PROPELLER SHAFT

■ DESCRIPTION

Two-Part Type (For Short Wheel Base Model)

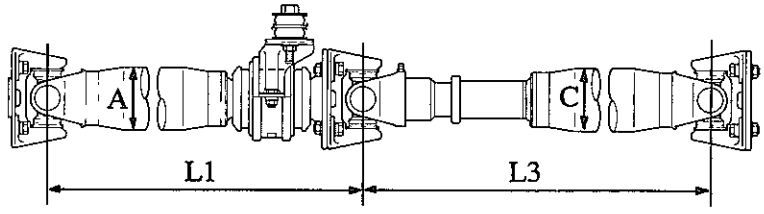
In addition to the two-part type propeller shaft used previously, a new three-part type is also used. The two-part type is used in the short wheelbase models, and the three-part type in the long wheelbase models. They are both equipped with the same Hooke's universal joint used in the previous model.
